RFP #18/19-03

Addendum #1

Internal Connections/Cabling for Vista Verde
Elementary and Heritage School
E-Rate Year 22 (2019/2020) Category 2

HERITAGE

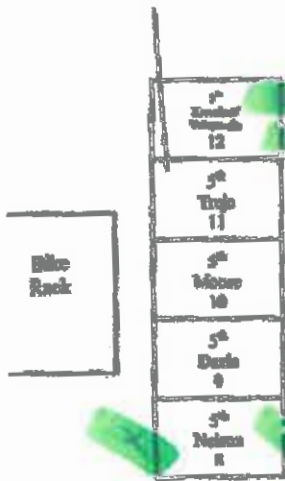
- H. County Rooms/Building - Included in Scope of Work and identified on Drop Map.

Vista Verde Elementary

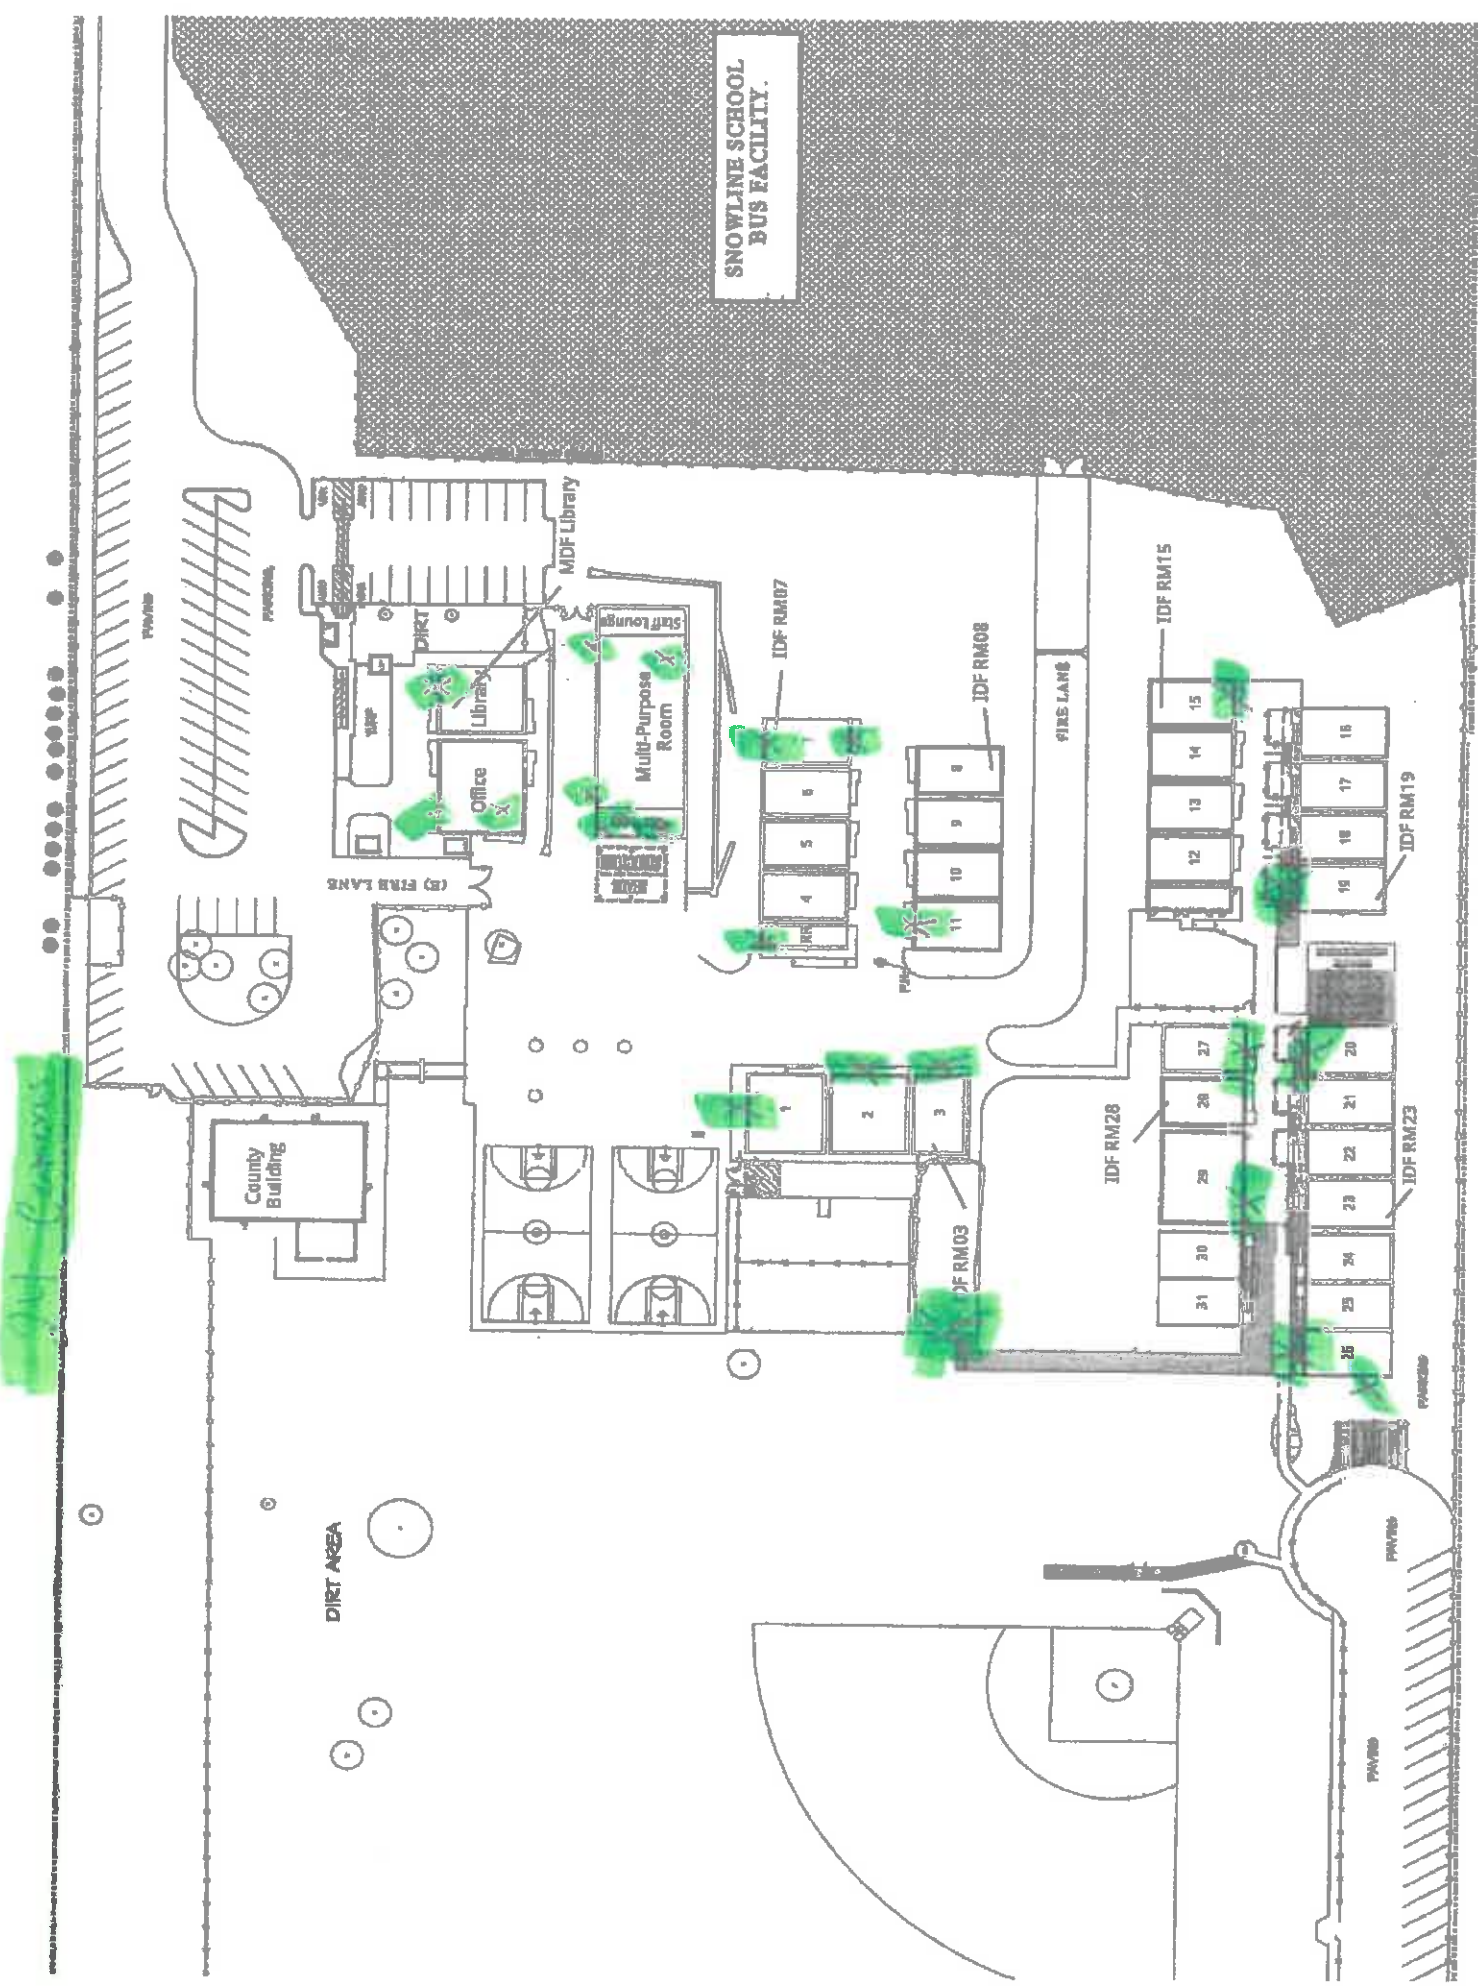
- A. Office IDF in Electrical Room – We are not replacing the cabinet.
- B. There is a mixture of underground and above ground conduit paths. The portables have underground conduit and loops between the buildings from the IDF.
- C. Pathways – Contractors can go through above or underground.
- D. Room 18 MDF – Ceiling Drops at center of room, terminate at the biscuit and label. Contractor is responsible for relocating the Access Point to the center of the room by the drop.
- E. County Rooms – Room 5 & 7 – Included in Scope of Work and identified on Drop Map.
